AGENDA PLANNING COMMISSION OF THE CITY OF WHITE BEAR LAKE, MINNESOTA MONDAY, FEBRUARY 28, 2022 7:00 P.M. IN THE CITY HALL COUNCIL CHAMBERS

То:	The Planning Commission
From:	Samantha Crosby, Planning & Zoning Coordinator
Date:	February 28, 2022
Subject:	Pitlick Residence Expansion / 4264 Cottage Park Road / Case No. 22-2-V

Tyler and Sara Pitlick are requesting a 31.5 foot variance from the 35 foot street-side setback in order to expand the single-family residence northward by 22 feet. The variance would allow the west wall of the addition to be 3.5 feet from the street side property line and the roof is designed with a 3 foot wide eave overhang.

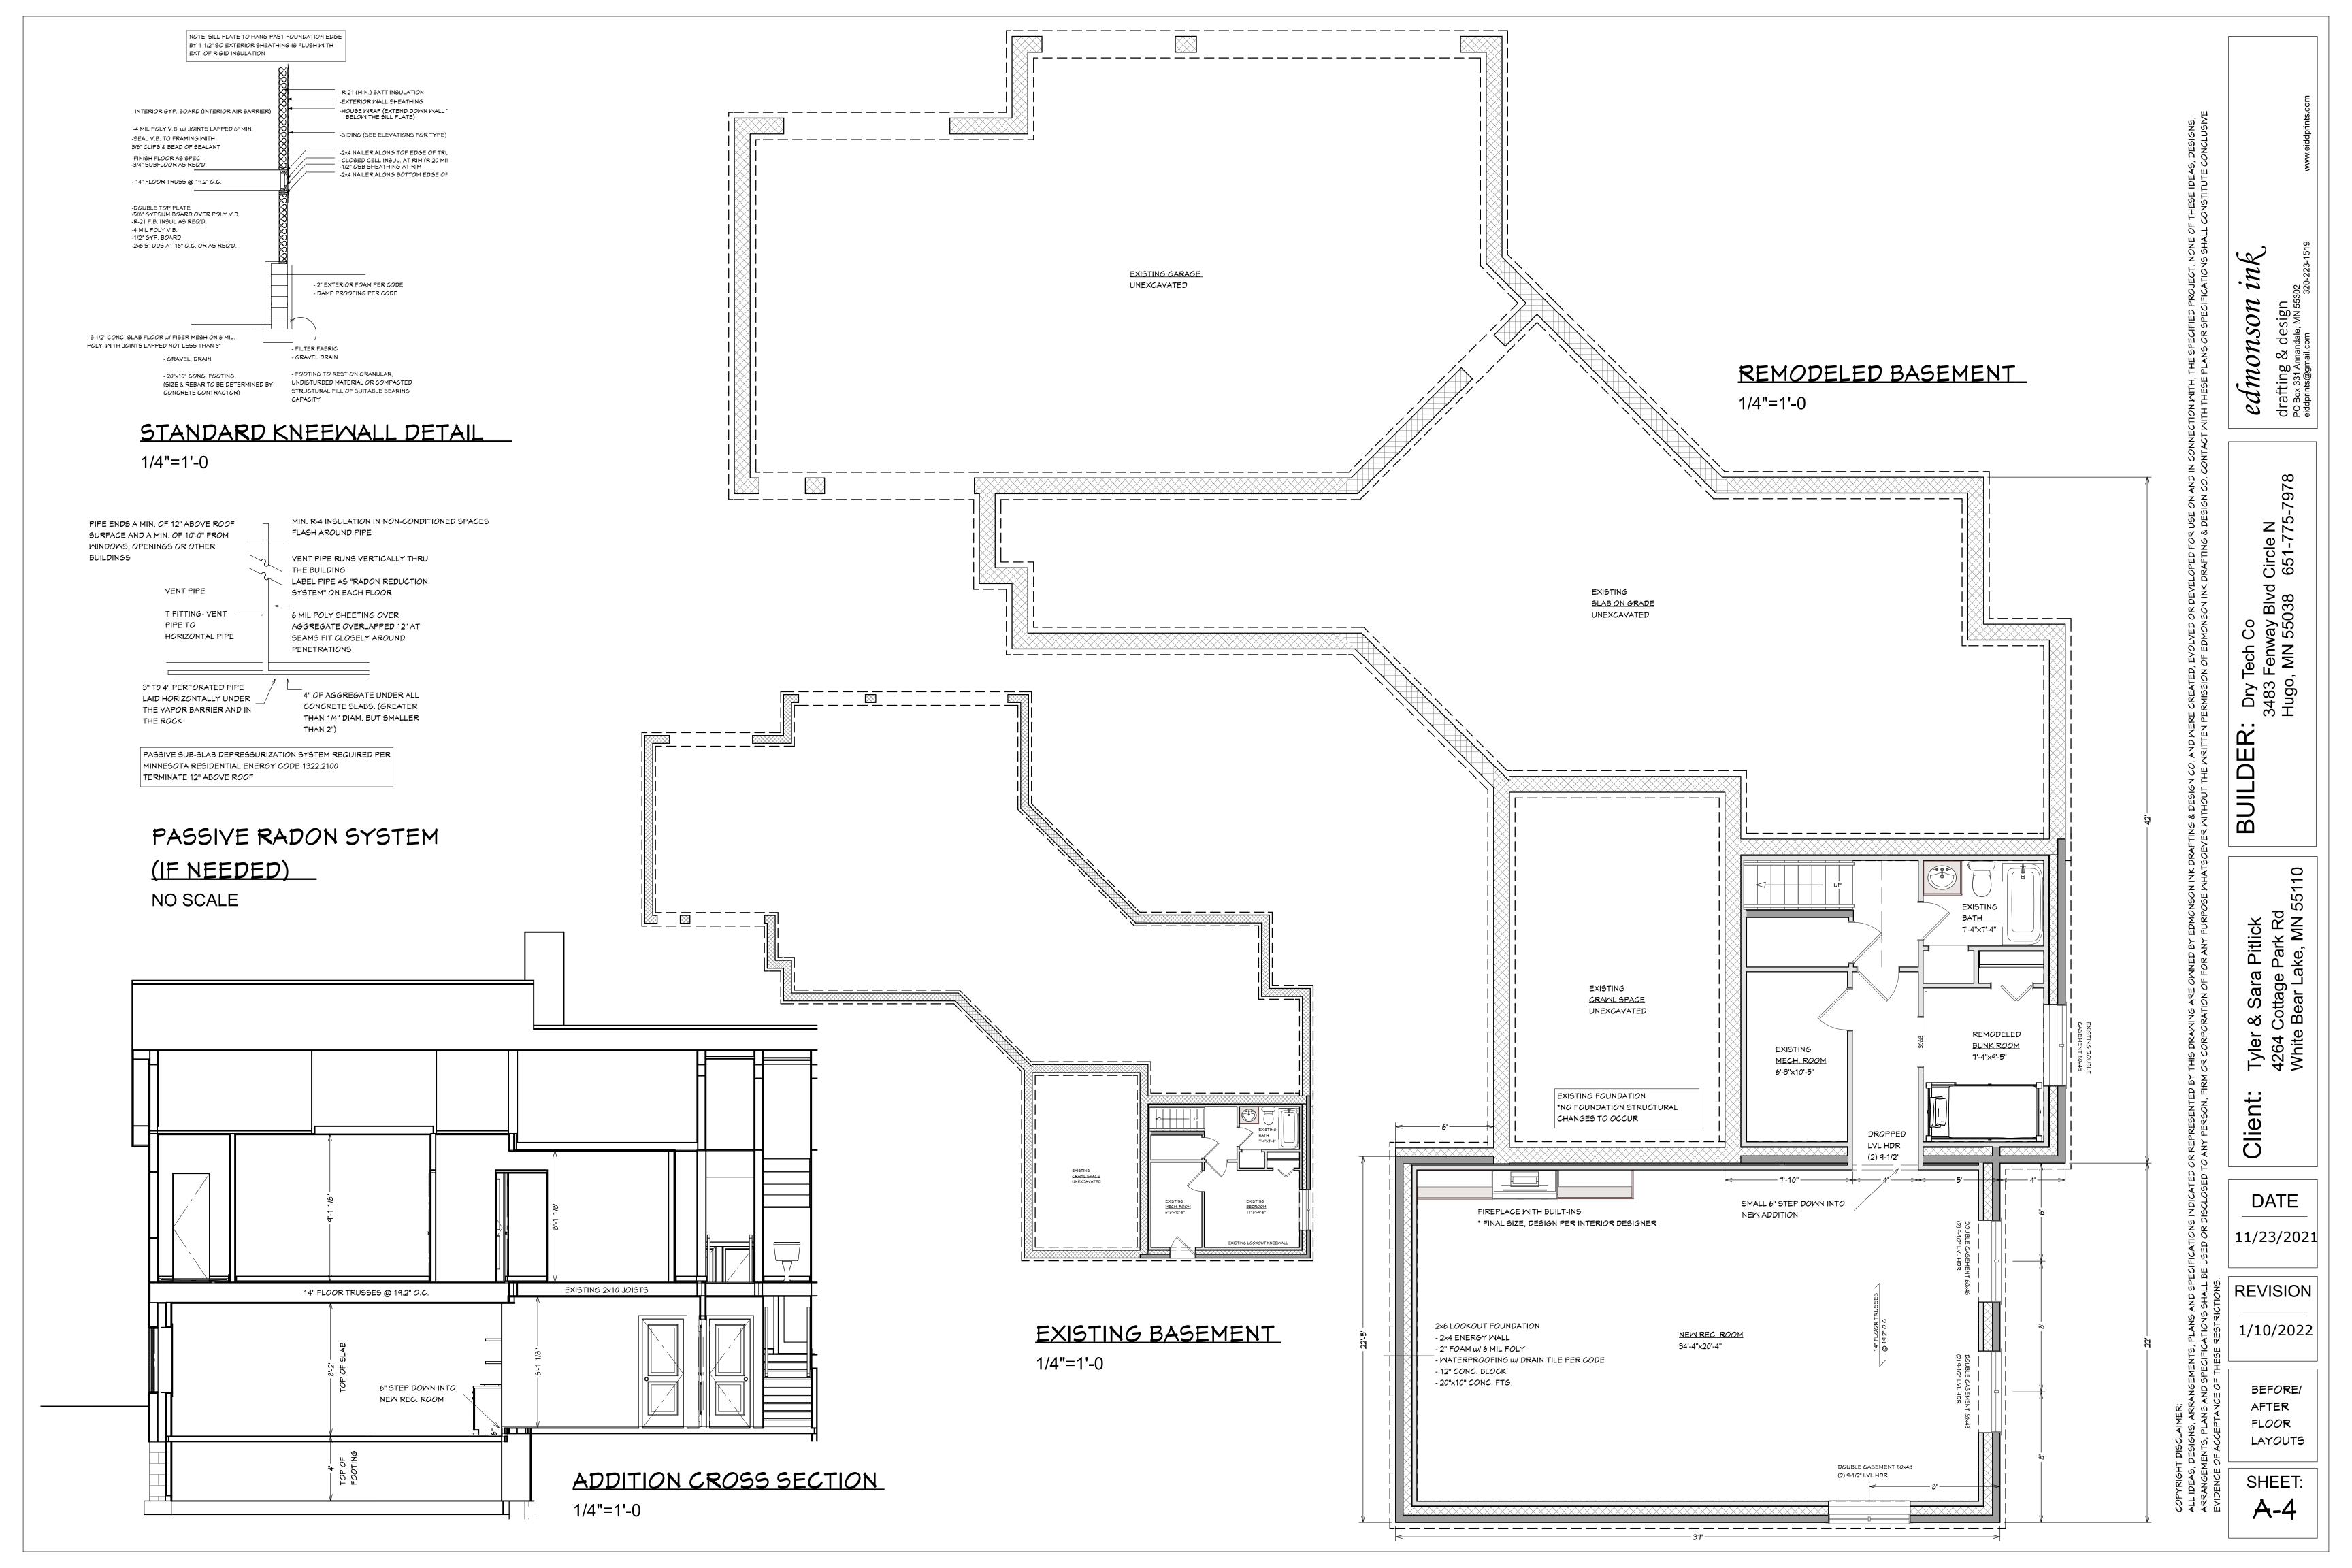
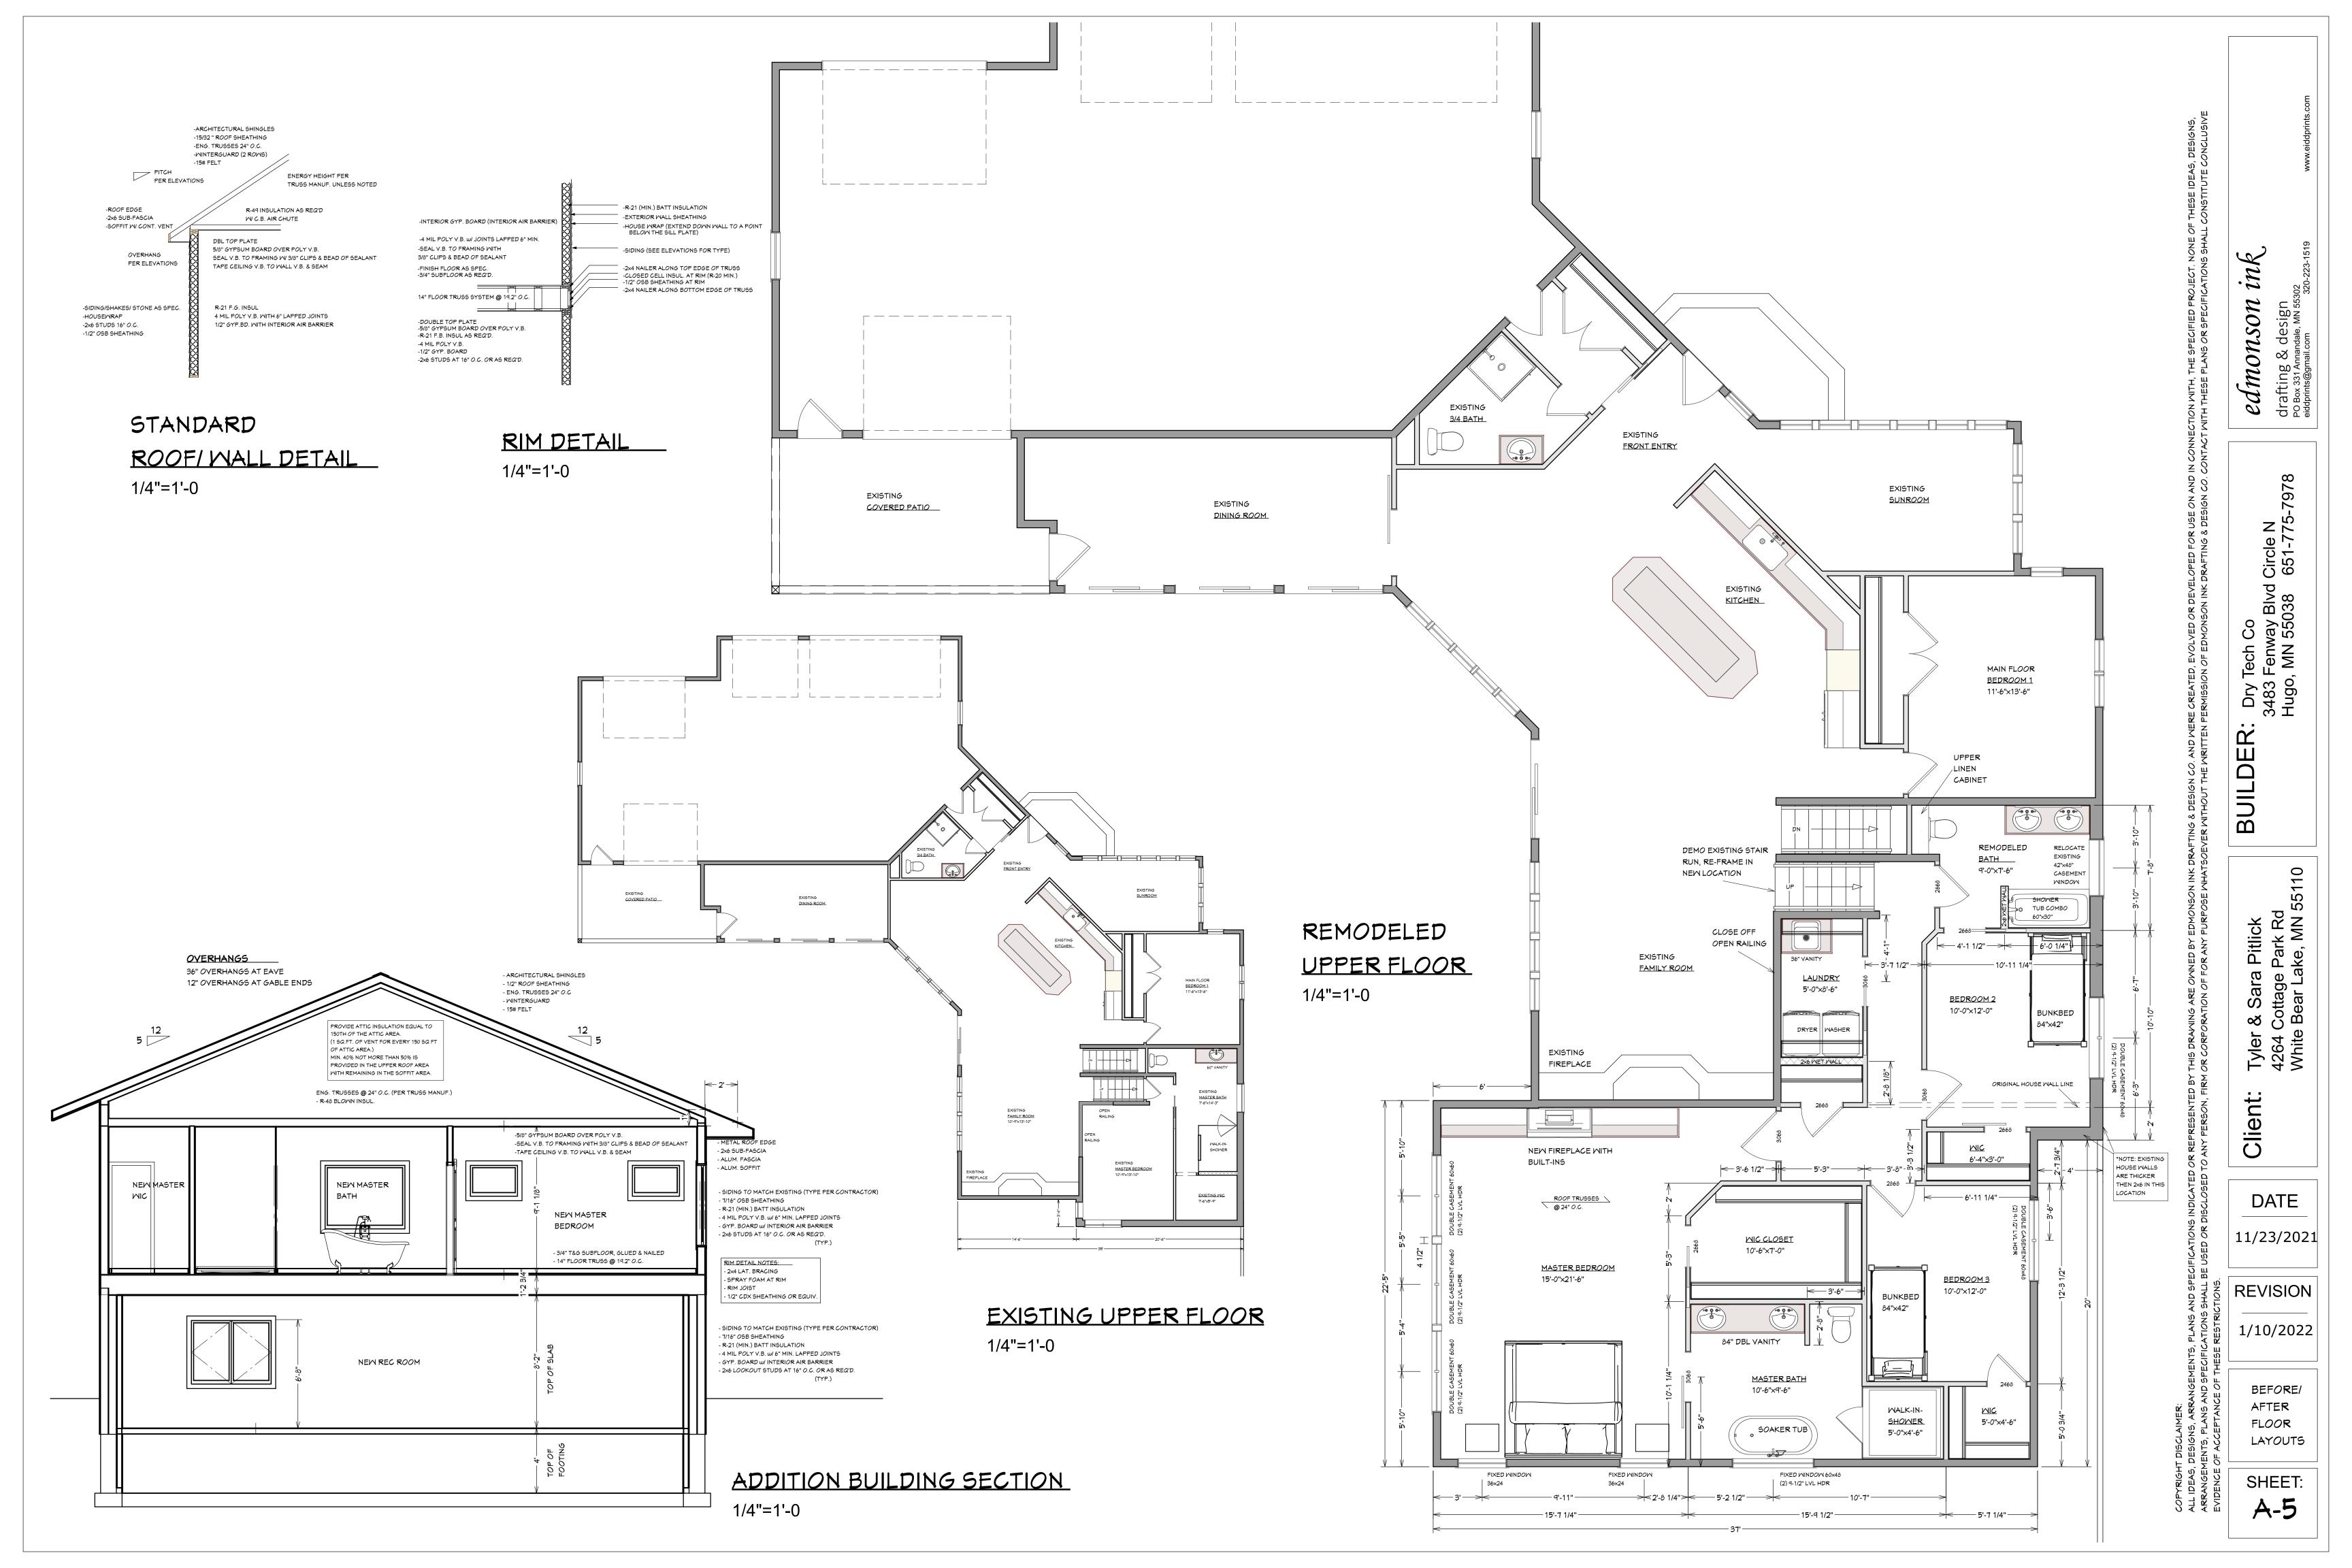
With the edge of the eave overhang being half a foot from the property line, the proposal provides very little setback. Is the setback the minimum necessary to alleviate the practical difficulty? Staff doesn't believe that it is. Pushing the proposed addition eastward would not encroach upon the existing deck or patio. While the proposed floor plan would likely need to be redrawn, there is plenty of space to both the north and the east should the shape of the addition need to change slightly in response to rearranging the floor plan to accommodate a setback that is more comparable with the established norm for the neighborhood.

Because the impervious area limitation would exceed 30%, the applicant would need to mitigate the impervious area by installing a rain garden or other infiltration feature per code. The feature will be relatively small so there is plenty of space to accomplish this on site. The addition should also be guttered to capture run-off from the roof and direct it away from the public right-of-way.

Because the applicant has not provided a practical difficulty as to why the addition cannot be designed to provide a greater amount of setback, more commensurate with the immediate neighborhood, staff recommends denial.

1. The project has not been proven necessary for the reasonable use of the land or building; alternative design options exist.

- 2. The request is not the minimum necessary to alleviate a practical difficulty.
- 3. The non-conforming use of neighboring lands, structures, or buildings in the same district would be the sole ground for issuance of the variance.
- 4. The proposal does not maintain the essential character of the immediate neighborhood because it is not in keeping with the average.
- 5. The granting of the variance would not be in harmony with the general purpose and intent of the code deviation from the code without reasonable justification will slowly alter the City's essential character.
